ADDENDUM

ADDENDUM NO.: **01**

PROJECT NAME: **Lake View High School Renovation Project**

DATE OF ISSUE: **April 19, 2017**

A5.1

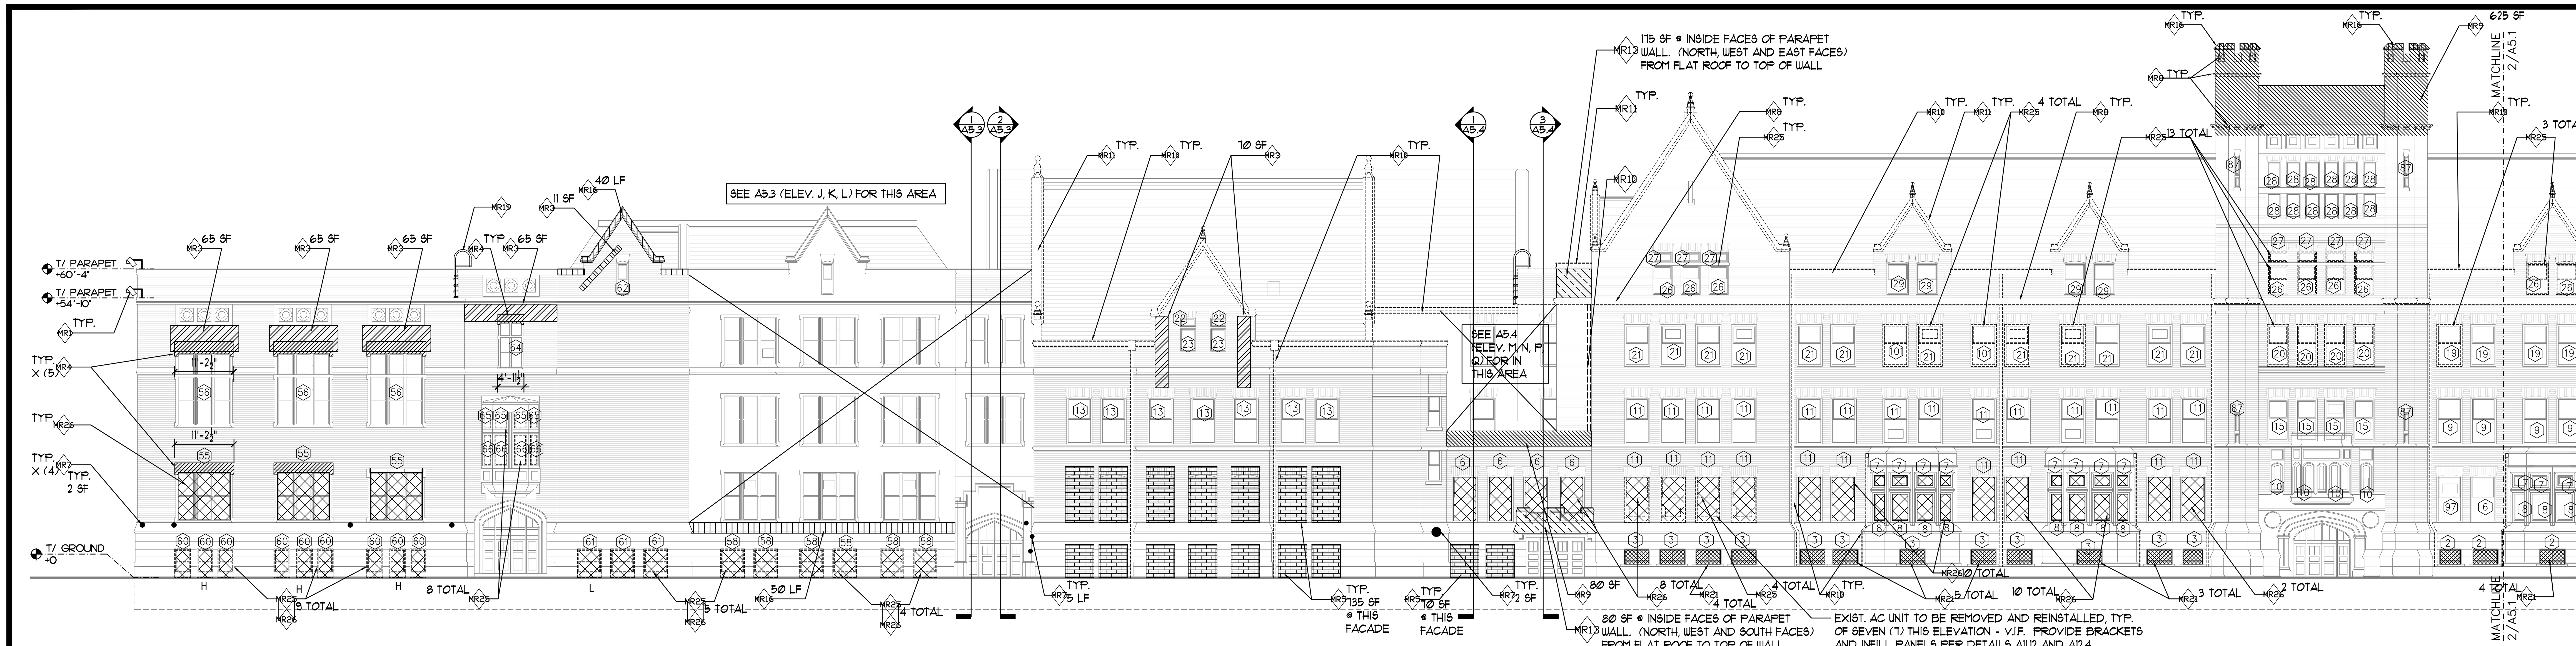
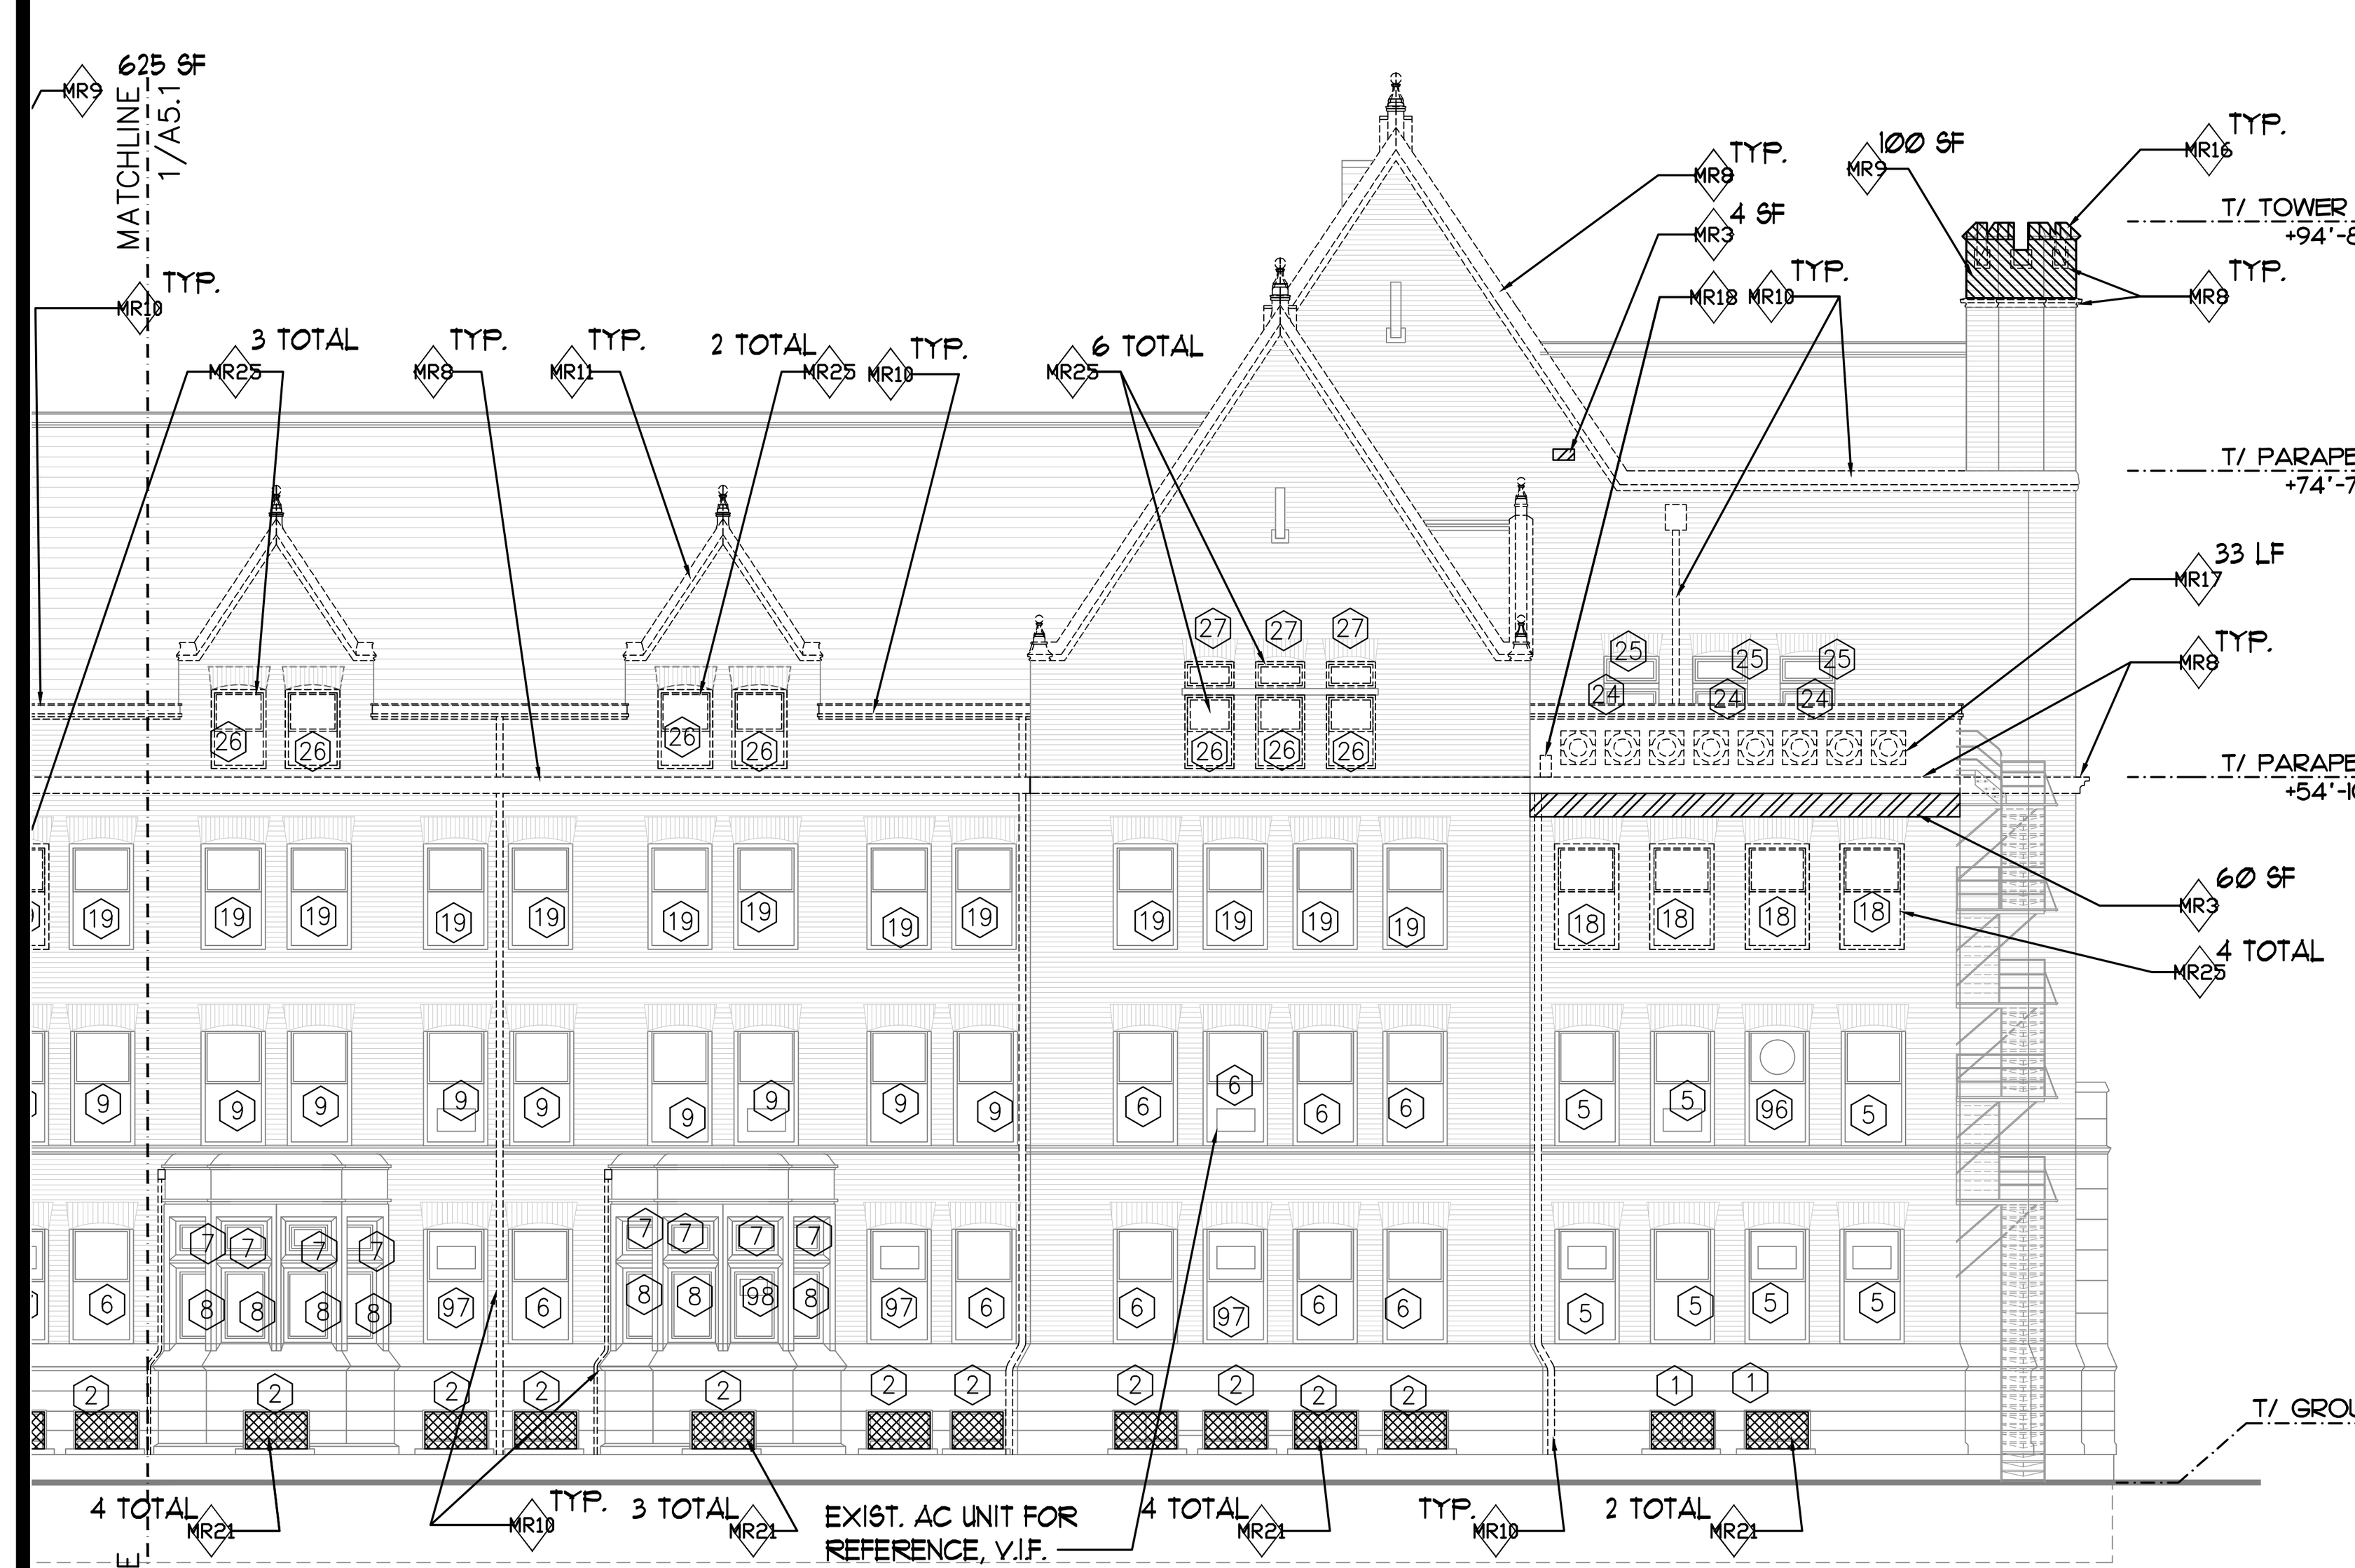
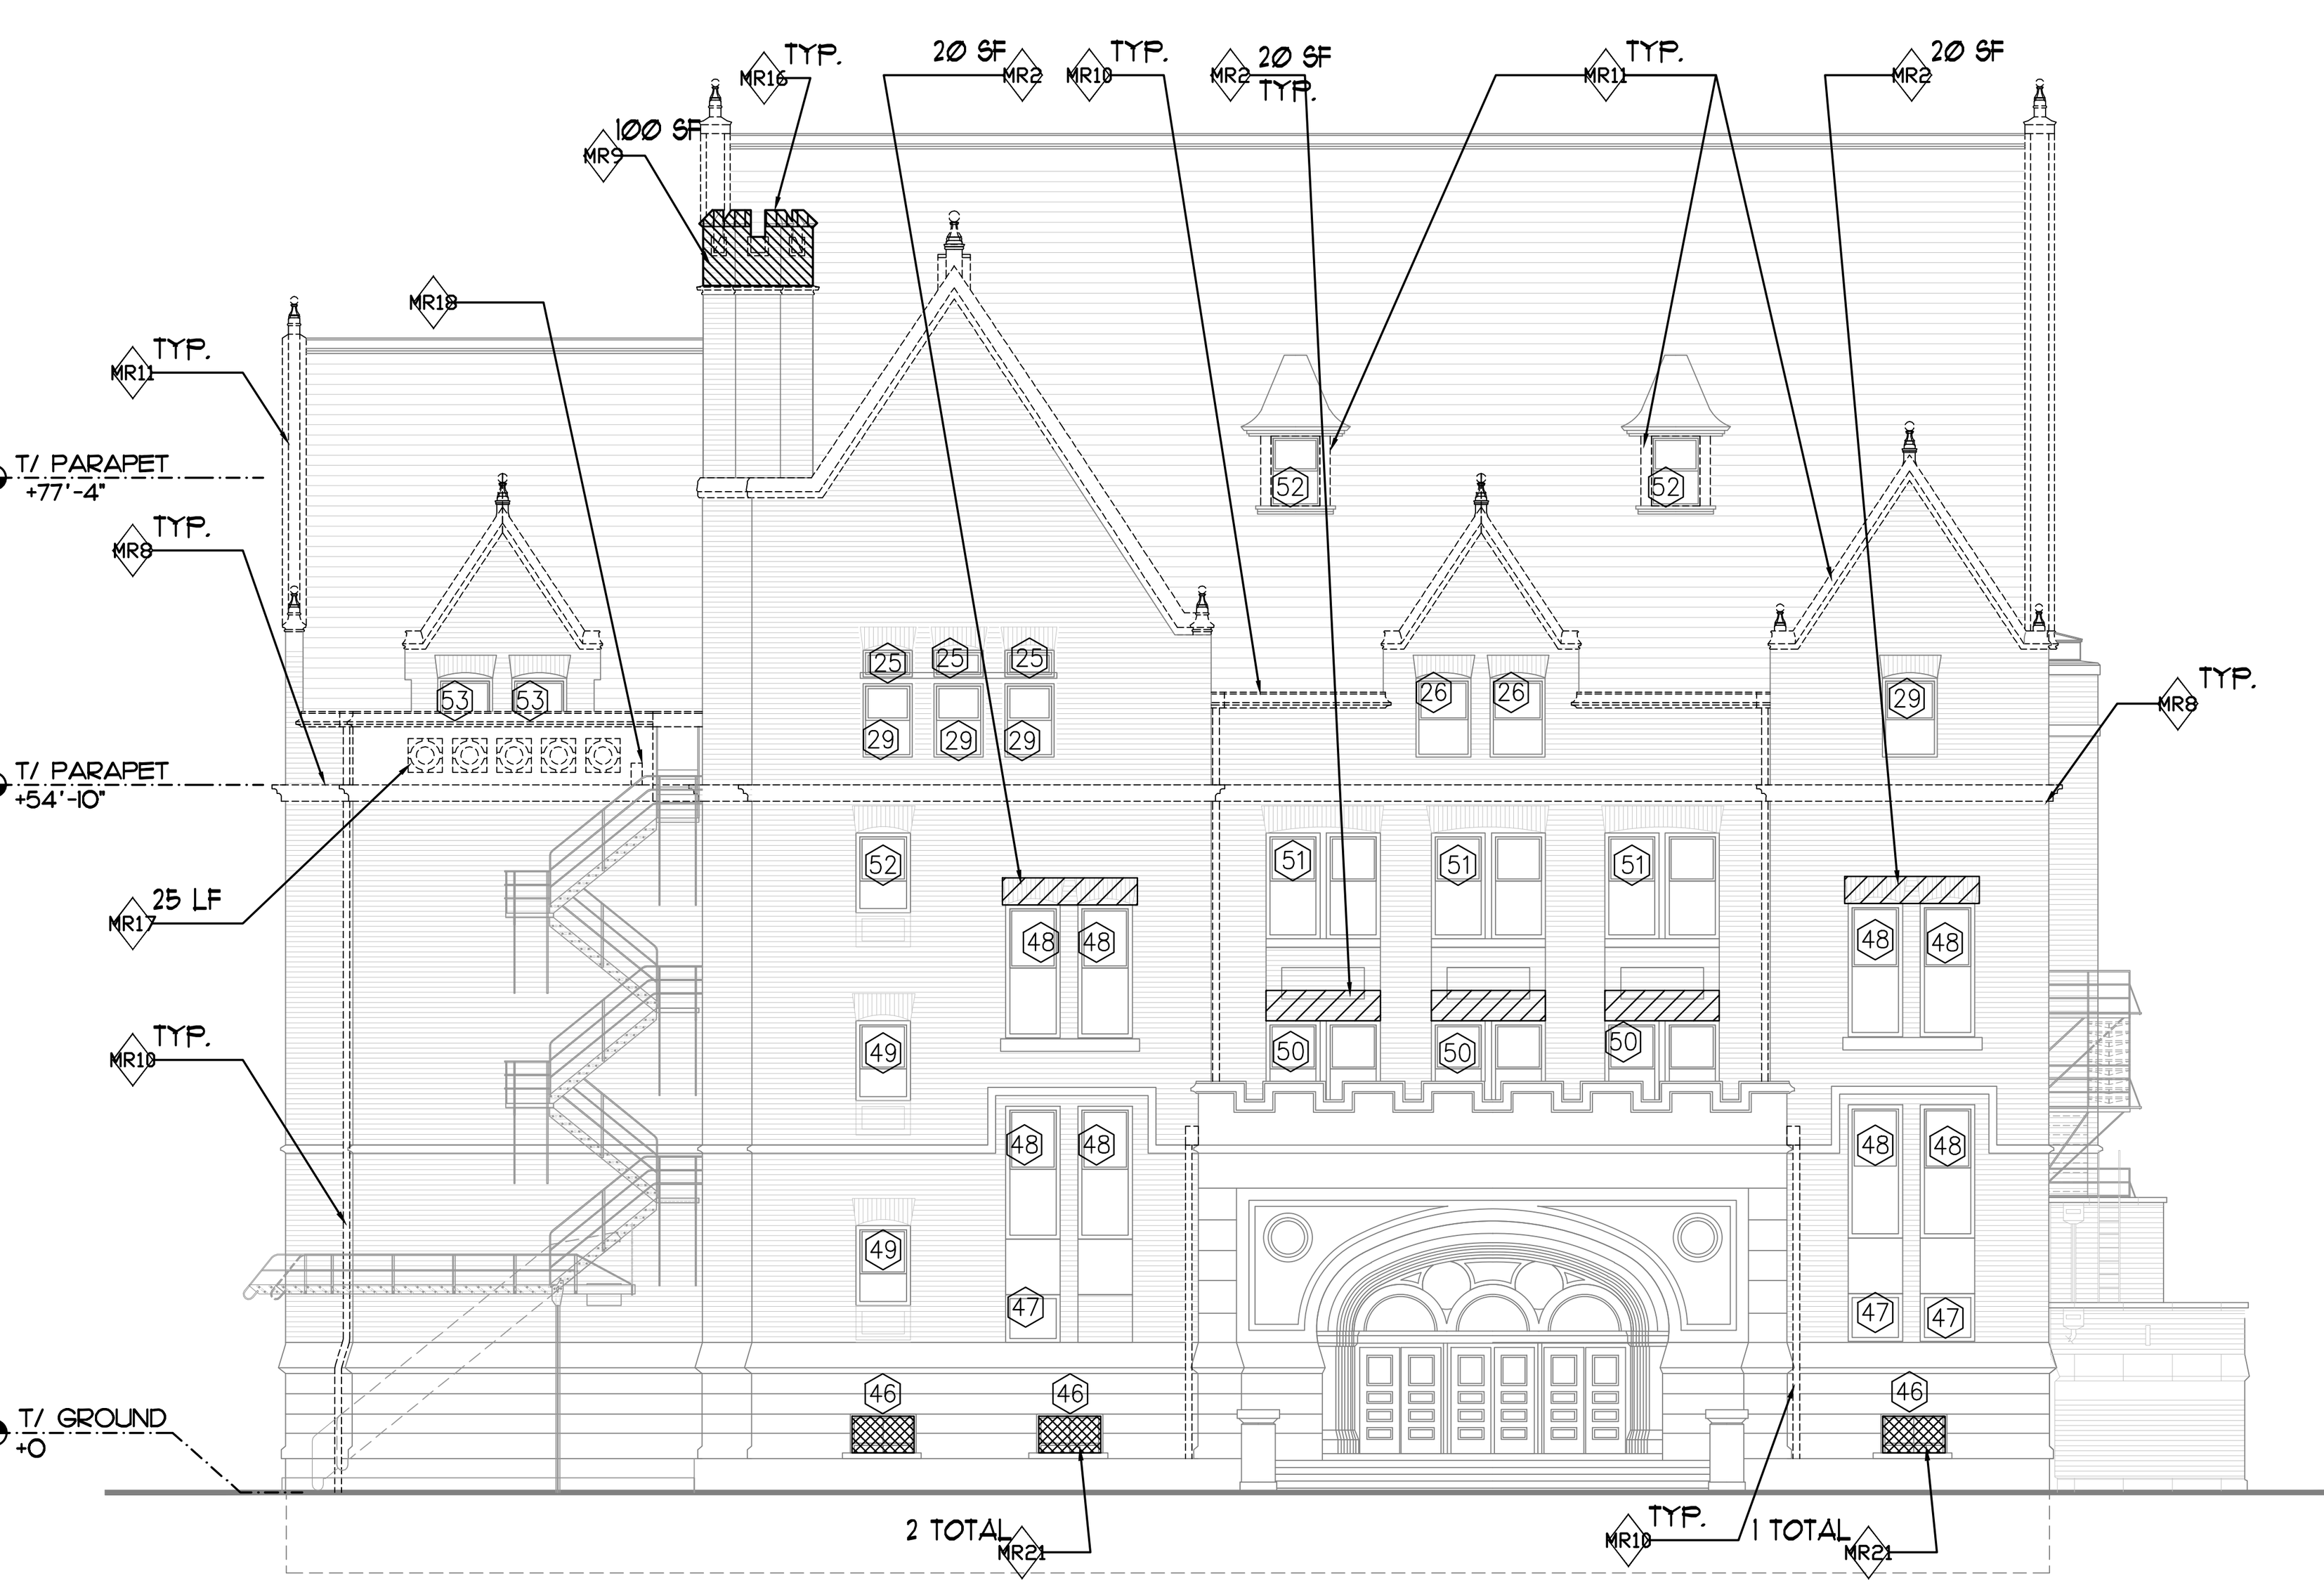
a. **REVISED** Drawing No. A4.0, ROOF DEMOLITION PLAN: Details 1 and 2 revised to clarify roof hatch types.
b. **REVISED** Drawing No. A5.1, BUILDING ELEVATIONS: Details revised to show all window types (for reference for manual shades, window trim refinishing, etc.). Existing window A/C unit removal / reinstallation scope also clarified.
